ADDENDUM TO CONTRACT DOCUMENTS

Project: Tigard Senior Center
8815 SW O'Mara Street
Tigard, Oregon 97223

Project No. 207037

Addendum No: 2

A604-R1

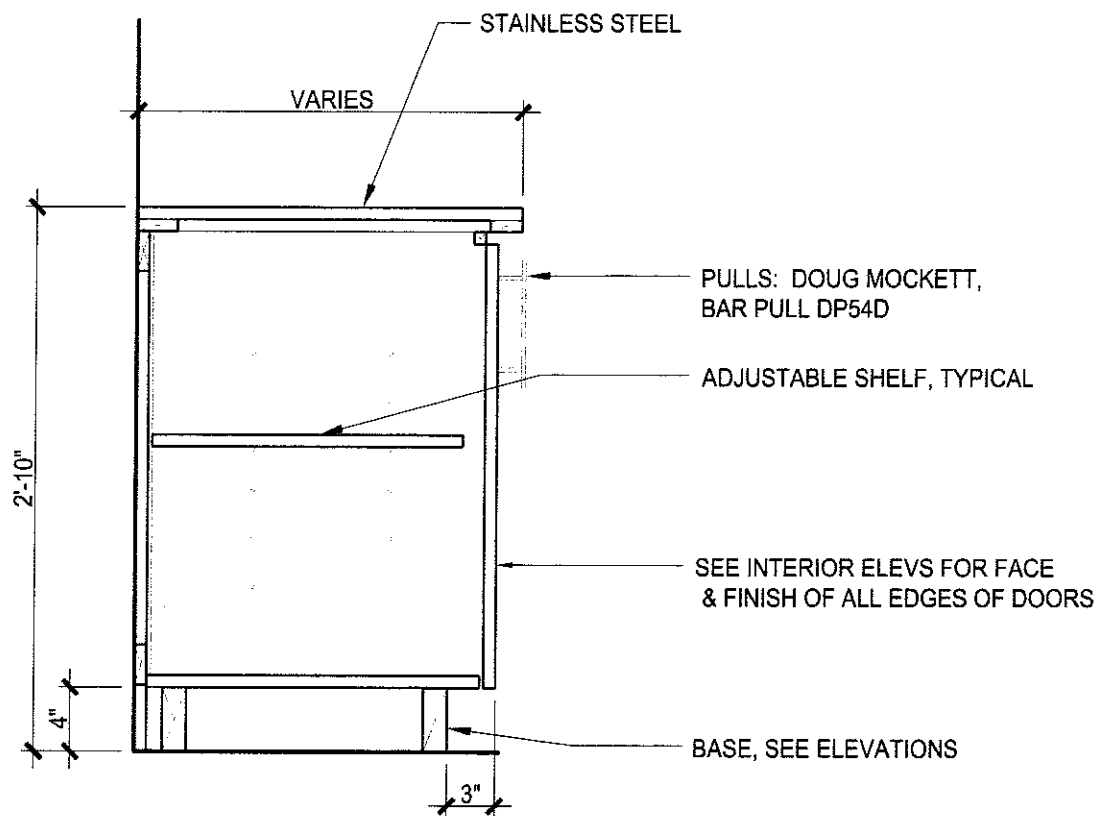
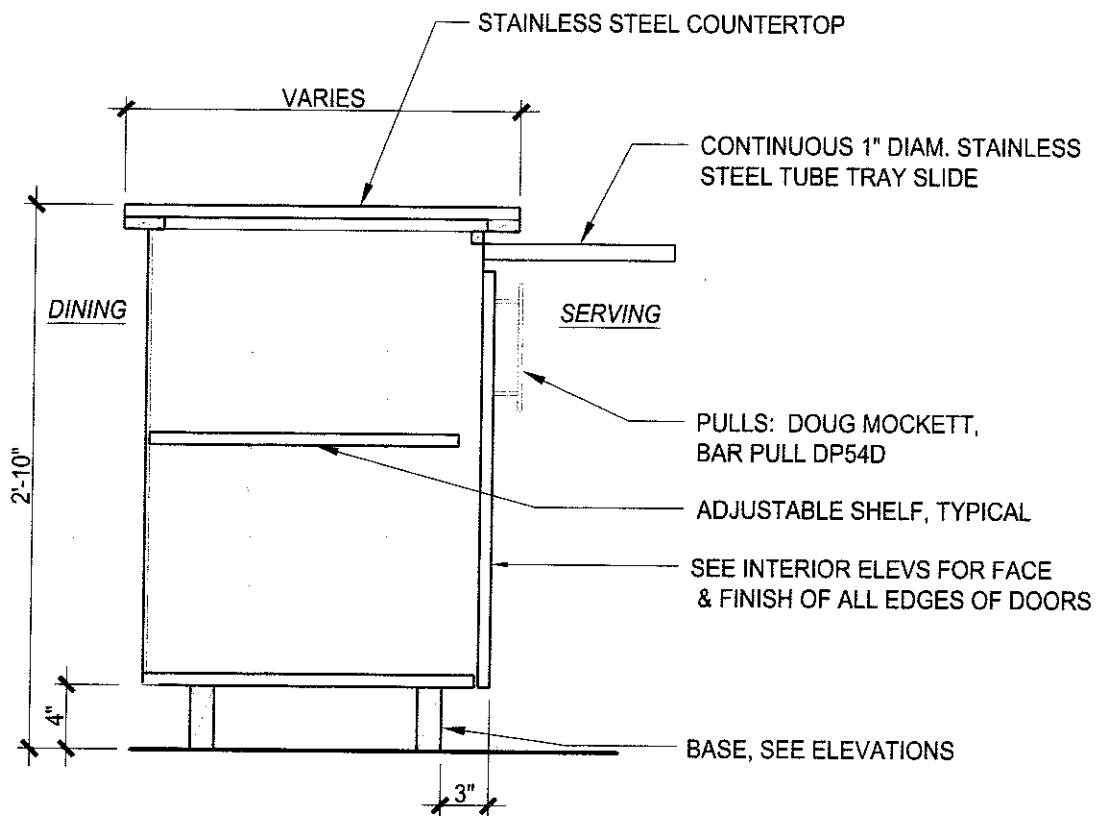
- Revise:** Drawing A604 as indicated in 8-1/2 x 11 inch Drawing A604-R1, dated 10-08-07, per attachment.
- Revise:** Drawing A604 as indicated in 8-1/2 x 11 inch Drawing A604-R2, dated 10-08-07, per attachment.
- Revise:** Drawing A604 as indicated in 8-1/2 x 11 inch Drawing A604-R3, dated 10-08-07, per attachment.

A701-R1

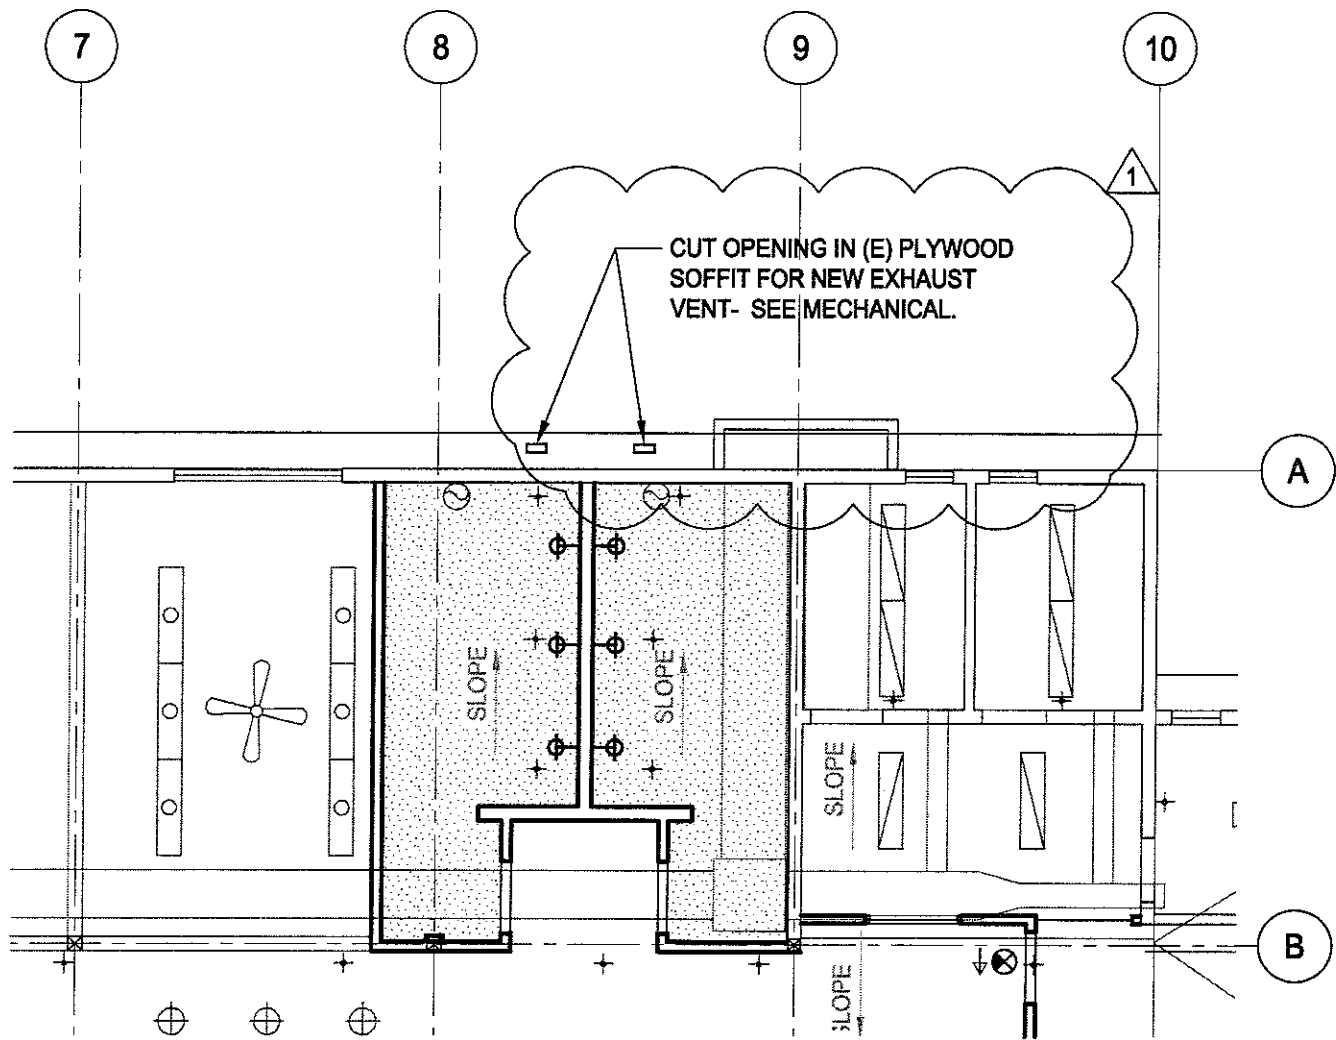
- Revise:** Drawing A701 as indicated in 8-1/2 x 11 inch Drawing A701-R1, dated 10-08-07, per attachment.

PL1.0-R1

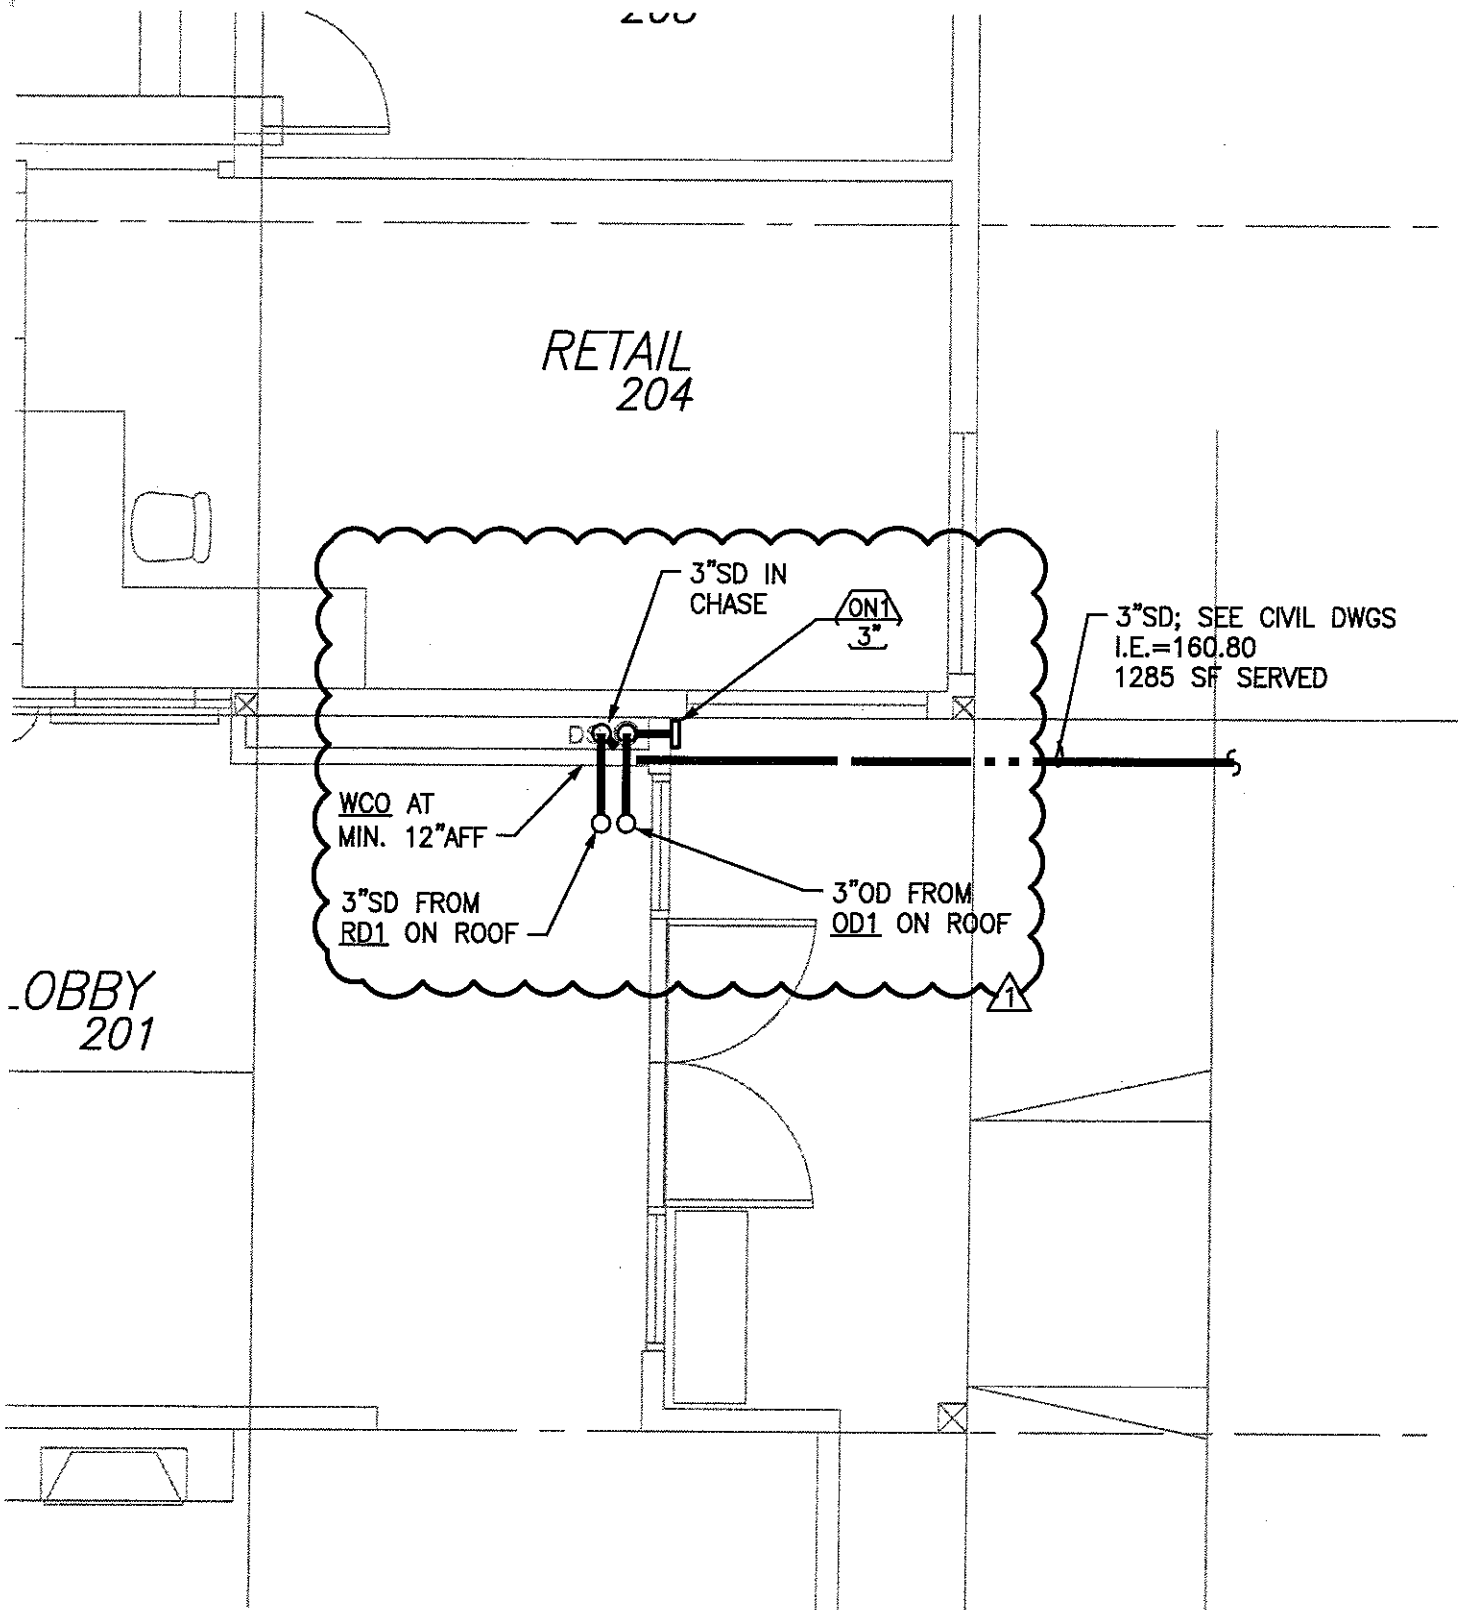
Revise: Drawing PL1.0 as indicated in 8-1/2 x 11 inch Drawing PL1.0-R1, dated 10-03-07, per attachment.
